## PRODUCT CHANGE NOTIFICATION (PCN)

<b>PCN#</b>	WPC-180306-001	<b>Issuing Date</b>	March 06 <sup>th</sup> , 2018
-------------	----------------	---------------------	-------------------------------

Product Name	Description	Supplying Schedule
W5500 Ethernet Shield	Revision: Rev1.0 → Rev1.1	March 06 <sup>th</sup> , 2018

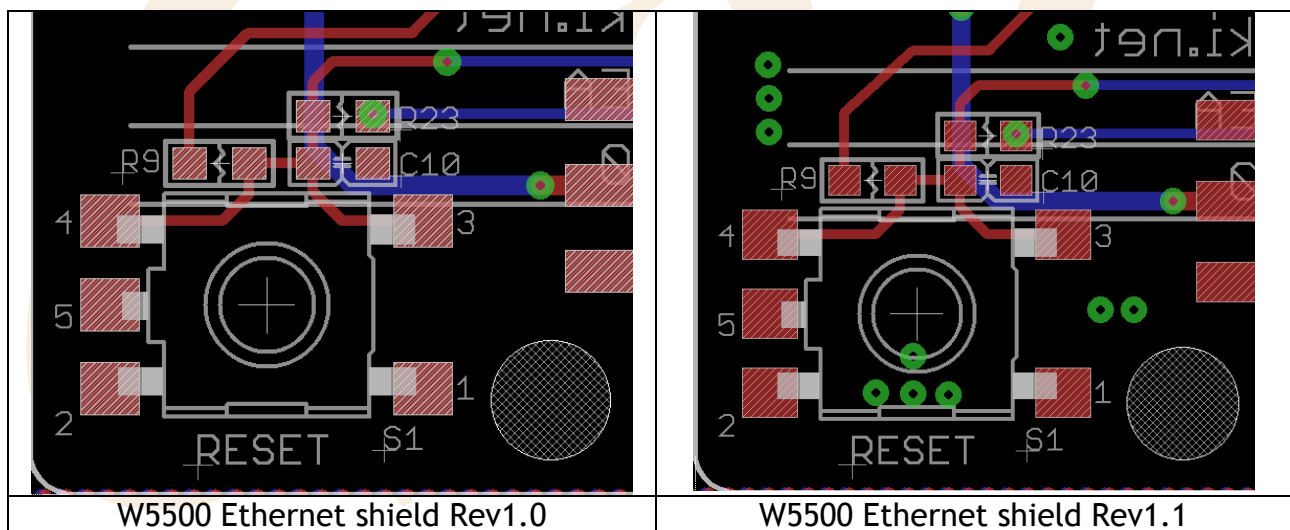
In Rev 1.0, GND pin of "RESET" button(S1) was floating.

This change in Rev1.1 will solve the floating problem. (Connect to GND with adding VIA.)

Refer to below picture.
